KELLEHER RESIDENCE 12 MONTPELIER PLACE MANLY

JOHN & CHRISTINE KELLEHER PROPOSED PLANS

LOWER GROUND AND GROUND

1:100 1908 DA02

GROUND FLOOR-PROPOSED PLAN

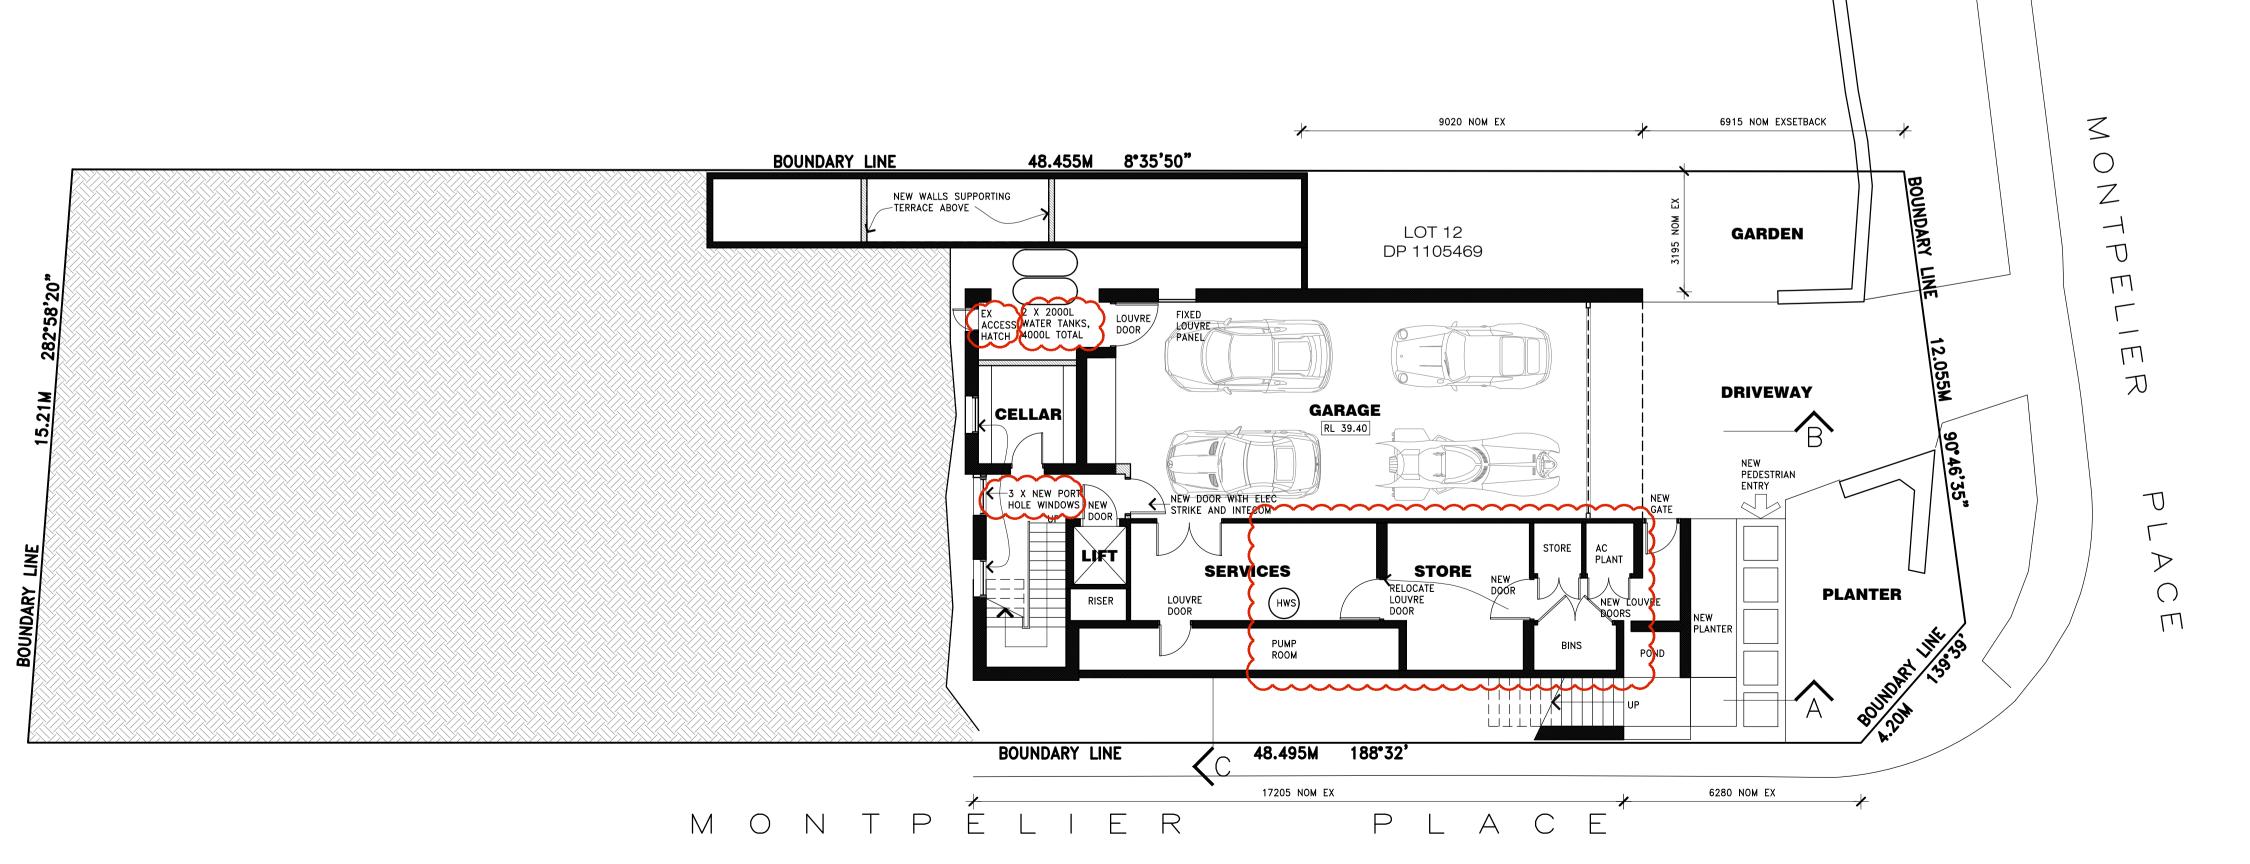
B RW 19/10/21 Basement— portholes added
Basement— RW tanks relocated Basement— Store and Service existing walls and doors clarified Ground—Kitchen walls changed, skylight increased

Ground— coat cpd added to Entry Ground— masonry fence added to east side Ground— pool retaining walls adjusted Ground— Games Rm door changed to sliding

FIRST FLOOR-PROPOSED PLAN

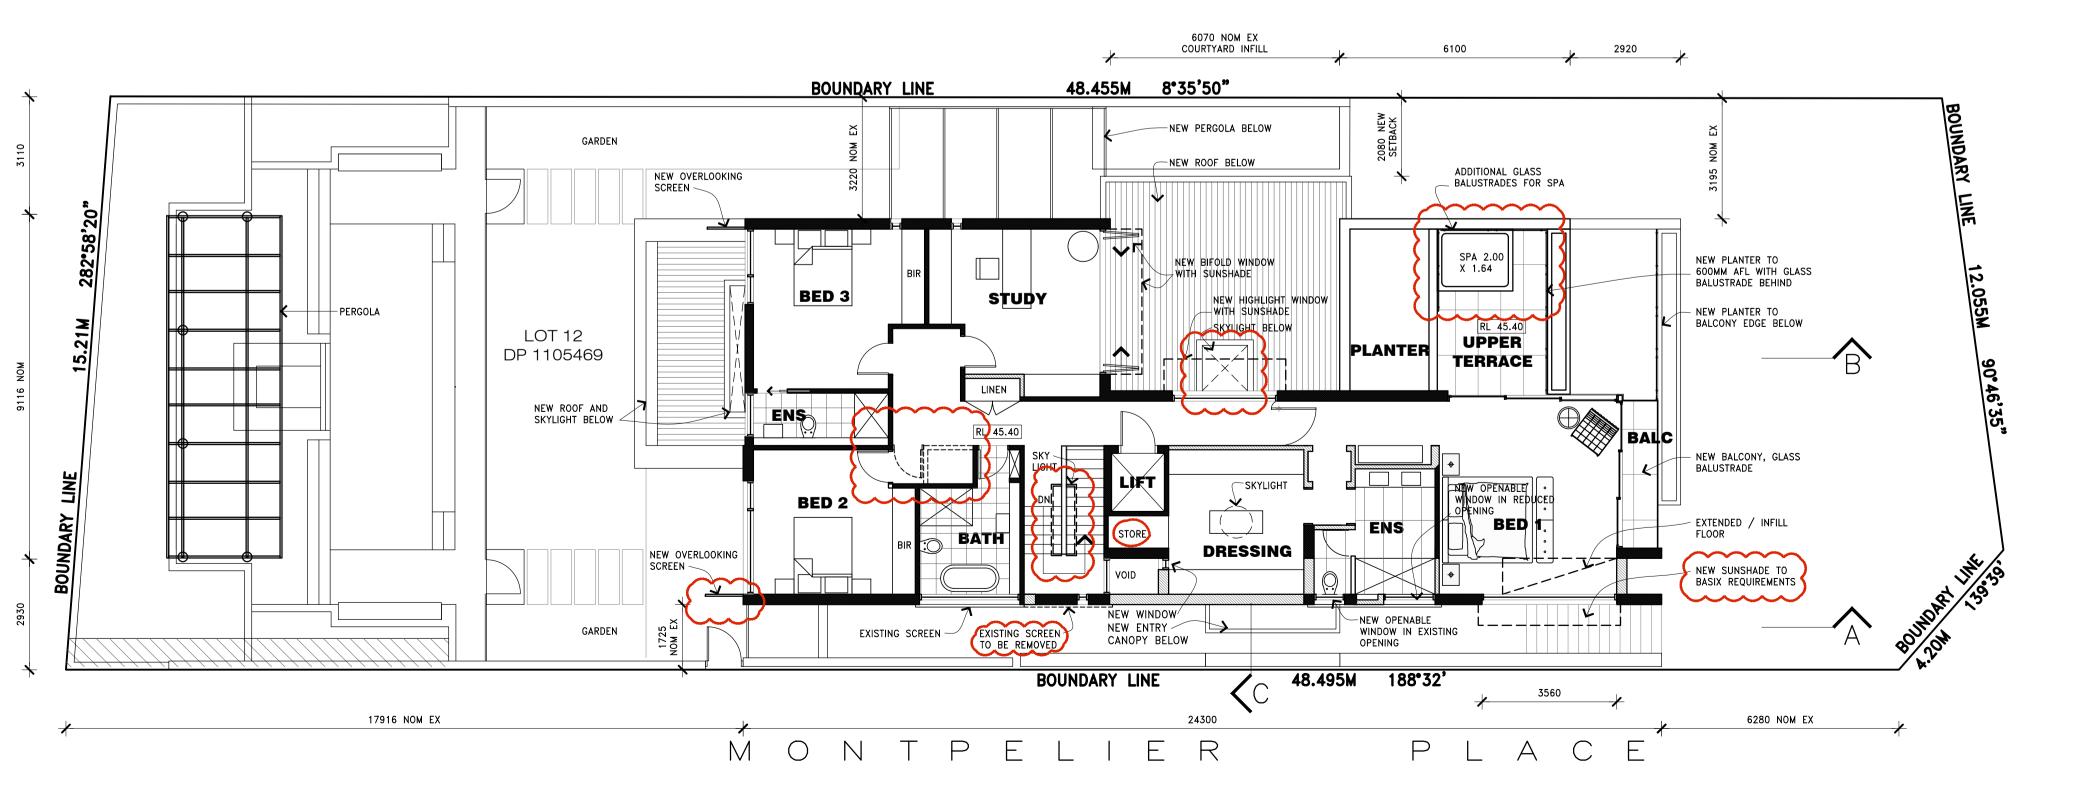
EXISTING WALLS TO BE RETAINED NEW WALLS B RW 19/10/21 Basement— portholes added Basement— RW tanks relocated Basement— Store and Service existing walls and doors clarified Ground—Kitchen walls changed, skylight increased Ground— coat cpd added to Entry
Ground— masonry fence added to east side
Ground— pool retaining walls adjusted
Ground— Games Rm door changed to sliding Upper— spa added to terrace, Upper— Bed 1 window east raised 200mm,
operable louvres deleted, awning added
Upper— skylight added to stairwell
Upper—corridor duct removed, no linen cpd Upper-door to Bedroom 2 changed
Upper- South Ensuite sill lowered 300mm Upper- Bed 2 window screen altered Upper— redundant louvres removed Roof— new solar system shown General— new and existing sunshade canopy detail changed to al. batten General— Wearthertex cladding changed to painted Scyon grooved panels General— boundary fences and retaining we clarified

EAST ELEVATION

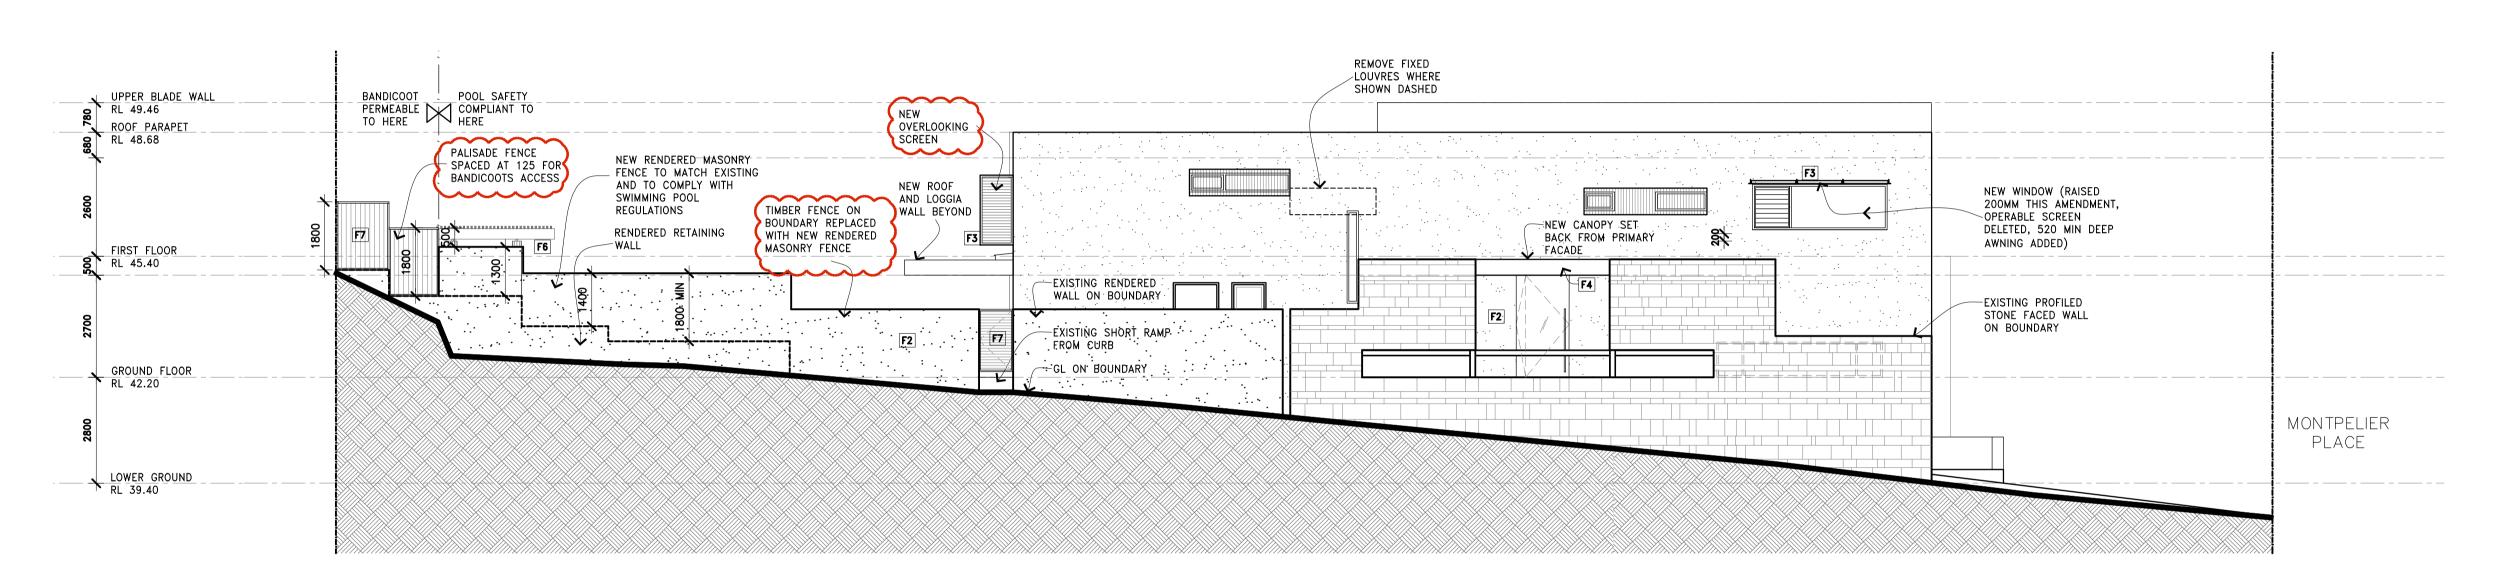
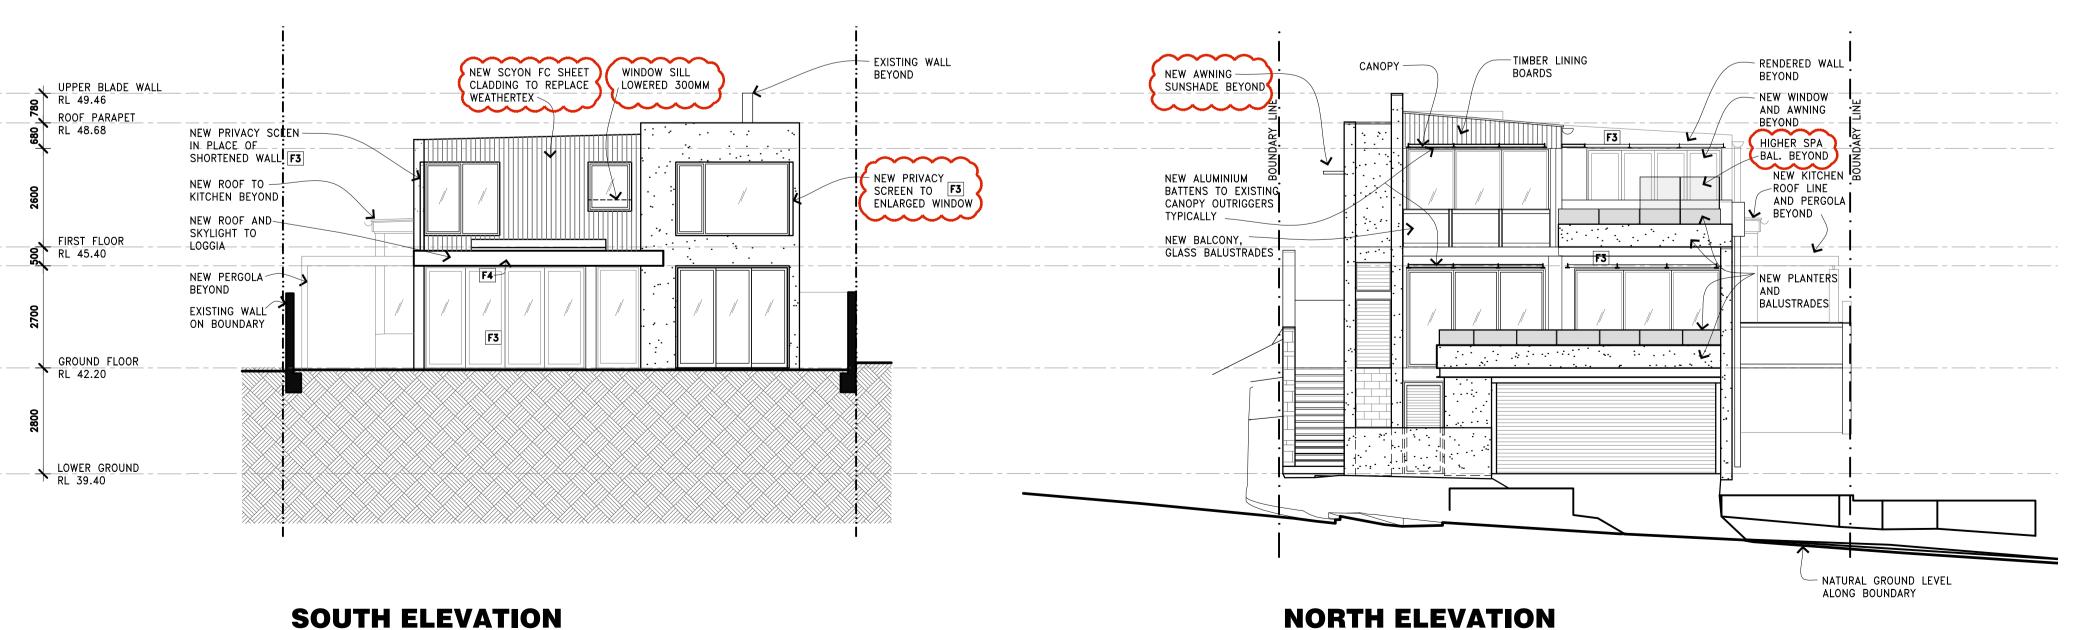
B RW 19/10/21 Basement— portholes added
Basement— RW tanks relocated
Basement— Store and Service existing walls and doors clarified
Ground-Kitchen walls changed, skylight increased
Ground— coat cpd added to Entry Ground- masonry fence added to east side Ground— pool retaining walls adjusted Ground— Games Rm door changed to sliding Upper— spa added to terrace, balustrades added Upper— Bed 1 window east raised 200mm,

operable louvres deleted, awning added
Upper— skylight added to stairwell
Upper—corridor duct removed, no linen cpd Upper-door to Bedroom 2 changed Upper- South Ensuite sill lowered 300mm Upper— Bed 2 window screen altered
Upper— redundant louvres removed
Roof— new solar system shown
General— new and existing sunshade canopy detail changed to al. batten General— Wearthertex cladding changed to painted Scyon grooved panels General— boundary fences and retaining walls General— Woodland Grey finish added

Planter added to front edge of balconies Balcony added to front of master bedroom Window added to east elevation
Window added to west elevation BBQ relocated adj Breakfast
Loggia /support for first floor S/W corner
changed
Fence added around pool terrace
Pool and safety fencing redesign lev By Date Amendment Details
